Office Action Summary

10/630,583

FRUTSCHY, KRISTOPHER J.

DETAILED ACTION

FIGURE A

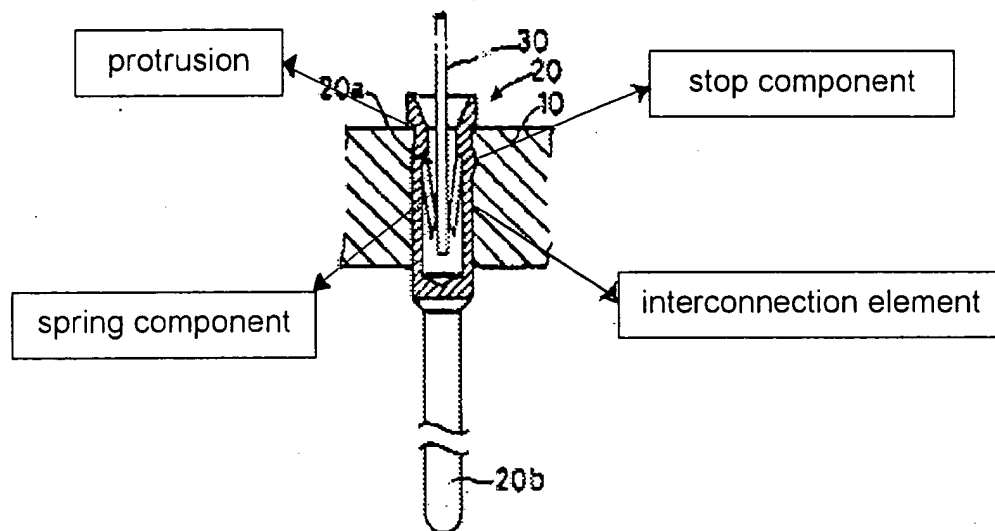
Regarding claims 1 and 10, Arisaka, figures 2-3 and a figure A (noted by an Examiner), discloses a socket for a microelectronic component, comprising:

- a socket body (10) having a formation for receiving the microelectronic component and including at least a first metal portion (14);
- a plurality of contacts (top side of socket pins 20-23) on the socket body;
- a plurality of terminals (20b) on the socket body;
- a plurality of interconnection elements (see a figure A below) in the socket body, each interconnecting a respective contact with a respective terminal;
- and
- a protrusion (the figure A below) on each interconnection element, a respective interconnection element and a respective protrusion being inserted into an opening in the socket body until the protrusion is in contact with the first metal portion, at least a first set of the interconnection elements all being

Regarding claim 3, a stop component (the figure A below) on the interconnection element to limit how far the interconnection element is inserted into the opening and to ensure that the protrusion is in line with the metal portion.

Regarding claim 8, a plurality of spring components (the figure A below) on the interconnection element, each contact being on a respective spring component.
